Urgent Field Safety Notice
Product Correction
Urgent - Immediate Action Required

March 7, 2019

Alinity ci-series issues resolved in software version 2.6.0

Alinity ci-series hardware issues resolved

Figure 1. Level Sensor, Bulk Solution identification label

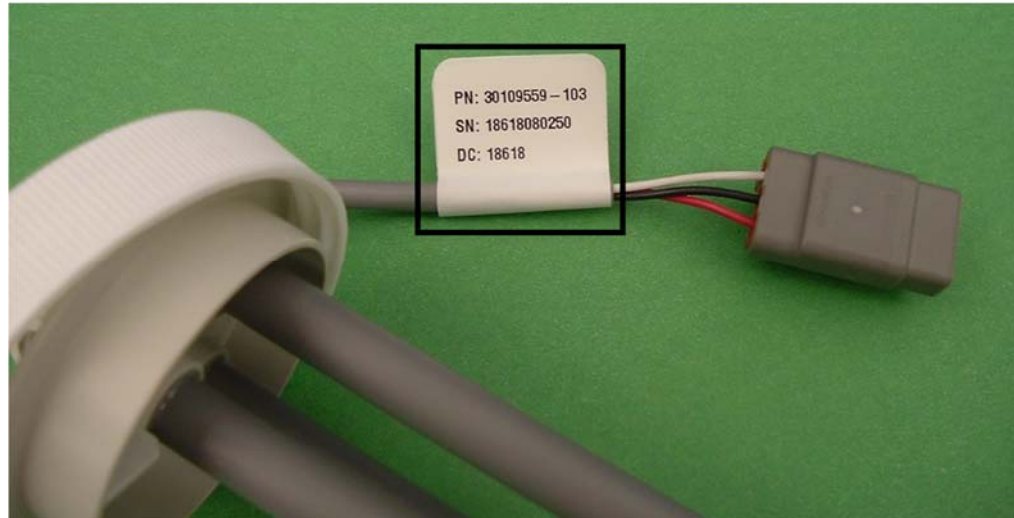
- If the part is in the box, the list number (04S68-01 or 04S68-02) is printed on the label
- If the part is removed from the box or installed on the Alinity ci series, the part number is printed on a label attached to the electrical connection for the part. See Figure 1 and Table 1 below.

List Number (LN)	Part Number (PN)	Instructions
04S68-01	30109559-102	Remove and replace any Level Sensor, Bulk Solution, LN 04S68-
04S68-02	30109559-103	01/PN 30109559-102 with LN 04S68-02/PN 30109559-103
